**Technical Service
Information Bulletin**

Title:
**FRONT AND REAR DIFFERENTIAL GEAR
OIL SPECIFICATION CHANGE**

Models:
'03 – '08 GX 470

**DRIVELINE & DIFFERENTIAL
DL003-07**

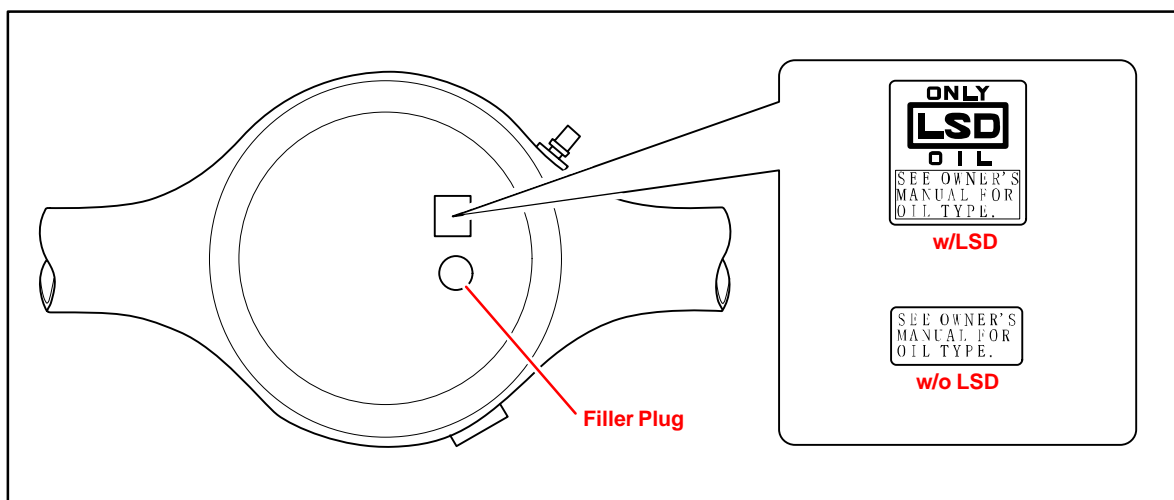
Introduction The differential gear oil used in GX 470 vehicles has been changed to a 75W–85 GL5 synthetic gear oil beginning with the 2008 model year. This new synthetic gear oil is compatible with 2003 – 2007 model year GX 470 differentials. Please refer to the Parts Information section below for information about this gear oil and use this gear oil (or equivalent) when filling front or rear differentials with oil.

Refer to the diagram below to identify if LSD or non–LSD gear oil is used on the vehicle. For applicable vehicles, there is a caution label above the filler plug, as shown below.

PREVIOUS PART NUMBER	CURRENT PART NUMBER	PART NAME	TYPE	QTY
N/A	08885-02606	Toyota Genuine Differential Gear Oil LX 75W–85 API GL–5 SAE 75W–85	LSD	As Needed
N/A	08885-02506	Toyota Genuine Differential Gear Oil LT 75W–85 API GL–5 SAE 75W–85	w/o LSD	As Needed
